CONSTRUCTION SUMMARY

Belle Aire Shores - Zancor Homes (Innisfil) Ltd.

LOT / PHASE	HOUSE TYPE	PRINT DATE
182N / 2	ADMIRAL 36-07 A (CORNER)	25-Oct-17

Lot 1822
06 10/17

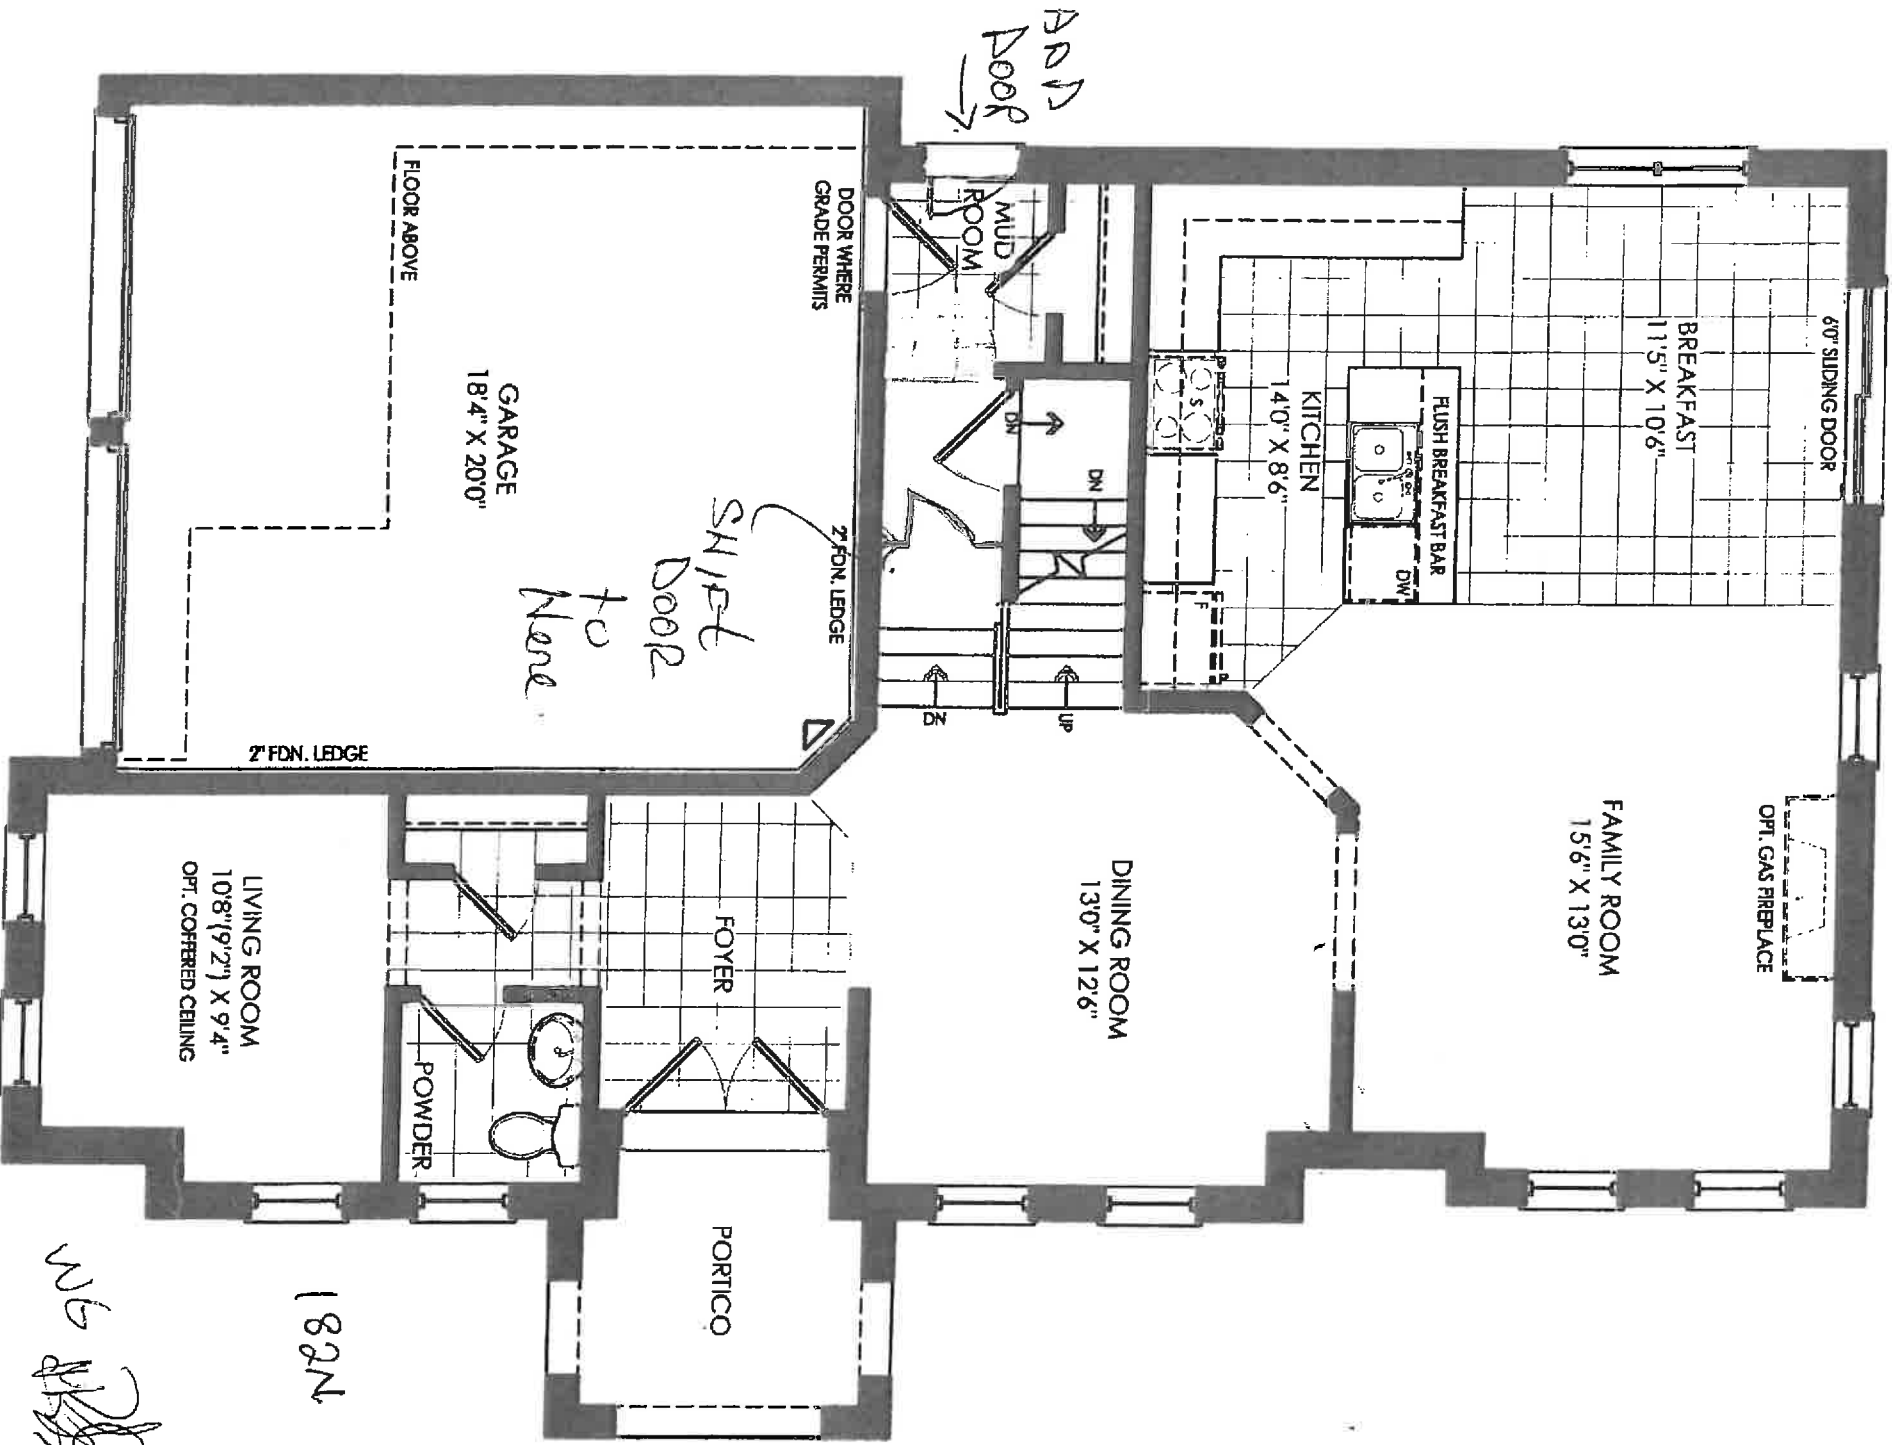
Ref#	Quantity - Description	Approved Notes	
5266	INSTALL (1) EGRESS WINDOW AT SIDE REAR WINDOW WELLS WILL BE INSTALLED DUE TO GRADE	25Oct17	
5267	INSTALL (1) EGRESS WINDOW AT FRONT OF BASEMENT WINDOW WELLS WILL BE INSTALLED DUE TO GRADE	25Oct17	
5268	INSTALL ROUGH INS ONLY FOR FUTURE KITCHEN AREA ROUGH IN ELECTRICAL AND VENTING FR FUTURE STOVE, ROUGH IN ELECTRICAL FOR FUTURE FRIDGE, ROUGH IN PLUMBING FOR FUTURE SINK, WATERLINE FOR FUTURE FRIDGE SEE ITEM 7 AND 8 FOR DIMENSIONS	25Oct17	
5269	ADD EXTERIOR DOOR IN MUDROOM IN LIEU OF STANDARD WINDOW NOTE ELECTRICAL WILL BE DONE WITH FINISHES	25Oct17	
5270	MUD ROOM SHIFT DOOR CLOSE TO THE STAIRS AS POSSIBLE SEE SKETCH	25Oct17	
5271	ELECTRICAL ADD 200 AMP SERVICE	25Oct17	
5272	ELECTRICAL BASEMENT ROUGH IN ELECTRICAL FOR FUTURE STOVE 102 INCHES FROM BASEMENT JOG SEE SKETCH ROUGH IN ELECTRICAL AND WATER LINE FOR FUTURE FRIDGE APPROX 16" FROM BASEMENT JOG SEE SKETCH	25Oct17

5273	PLUMBING BASEMENT INSTALL ROUGH IN FOR FUTURE SINK APPROX 58" FROM JOG SEE SKETCH	25Oct17	
5275	PLUMBING INSTALL ROUGH IN ONLY CENTRE OF WALL FOR STACKABLE WASHER AND DRYER FOR FUTURE LAUNDRY ROOM INCLUDES PLUMBING ROUGH IN AND ELECTRICAL AND VENTING NOTE NO LAUNDRY TUB	25Oct17	
5409	EXTERIOR - MODIFICATIONS TO ELEVATION A DUE TO ARCHITECTURE CONTROL ** As per Schedule E in Agreement of purchase and sale	25Oct17	
5410	BONUS: Granite kitchen countertops with undermount sink 3 Piece stainless steel appliances with white top loading washer and dryer Stainless steel under cabinet hood fan Extended uppers in kitchen (39-1/2") BBQ Gas line	25Oct17	
5411	BONUS: Air Conditioning (42ft and 50ft lots ONLY) 9ft main floor ceilings, 8ft ceilings on second floor 3-1/4 inch by 3/4 inch natural prefinished engineered hardwood on main floor in non-tiled areas, excludes bedrooms Natural finished oak stairs	25Oct17
